Substantive response of the Local Highway Authority to a planning consultation received under The Development Management Order.

Planning Application Number: 25/00931/FUL

Application Address: Cliffe Hill Farm Little Shaw Lane Markfield Leicestershire LE67 9PP

Description of Application: Re-consultation. Development of a logistics park for storage and distribution (Class B8), general industry (Class B2), ancillary office space (Class E) and associated infrastructure.

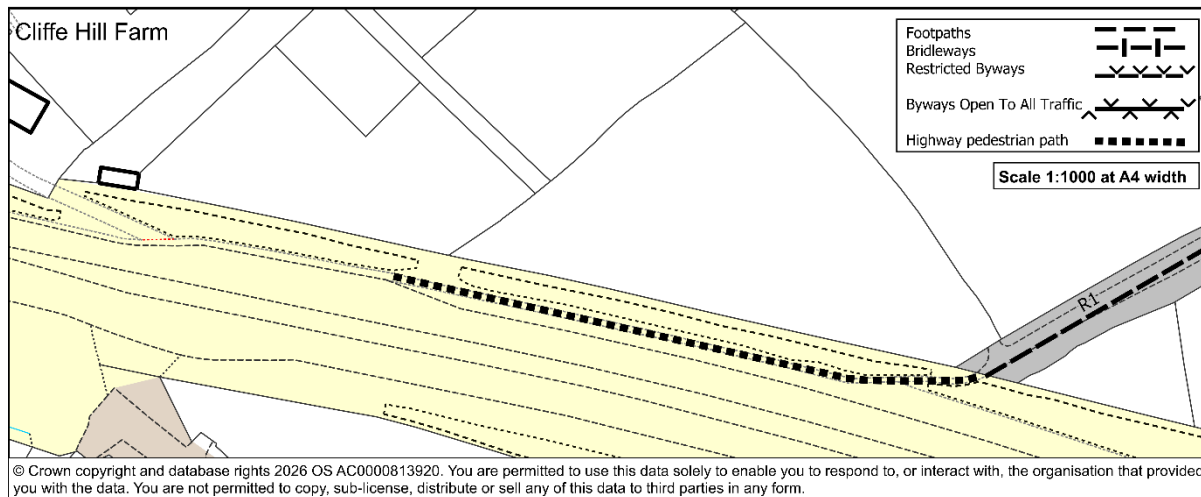
The Applicant's references to an 'informal path' confuse the route's physical appearance with its legal status, as shown by the map excerpt here:

The yellow and brown tints show the extent of adopted highway land. The grey tint is the extent of the public right of way. Under common law the public's rights extend to the whole area of the highway extents, whether 'adopted' or on the Definitive Map (see *R v United Kingdom Electric Telegraph Co Ltd (1862)*), also public highways are fundamentally continuous and connect with one another (see *Eyre v New Forest Highway Board (1892)*).

On the map extract the route shown as a 'Highway pedestrian path' was deliberately constructed as part of the building of the A50 Markfield Bypass in the late 1960s to restore a pedestrian link between Altar Stones Lane, via the A50 pedestrian crossing points and tarmac footway, to the truncated Cottage Lane which became a public right of way for pedestrians only. This constructed pedestrian path has the same legal status as an adopted footway, either at the roadside or as a 'remote footway'; the only difference is it does not have a tarmac surface. There are informal routes on roadside verges, but this is not one.

The Applicant has advised previously that the site ingress and egress roads are to remain in private ownership and not become adopted public highway. Therefore, legally, pedestrian access on those routes is 'by permission' rather than 'by right'. So those routes cannot be guaranteed alternatives to ones that have a public highway status. Ultimately the integrity of the public pedestrian highway network must be protected. To tarmac up to a certain point, and then deliberately create a 'No man's land' beyond that, seems contrary to the highway law and planning law outlined above. The LHA also notes in the revised drawing T22523 001 Rev. O, the link appears to have been removed altogether.

"In line with the NPPF, to enhance rights of way the rest of the route to link with PRow R1 should have a tarmac surface. The [Highway pedestrian path] will need to be upgraded to meet design and construction standards set out in the LHDG. For these works to be adequately monitored and delivered in accordance with these criteria the works to the highway [pedestrian path] will likely need to be included in a Section 38/278 Agreement."

The link would need to be hard bound and continue from the new site ingress, alongside the A50 and up the existing slope to Cottage Lane, maintaining the existing slope to Cottage Lane.
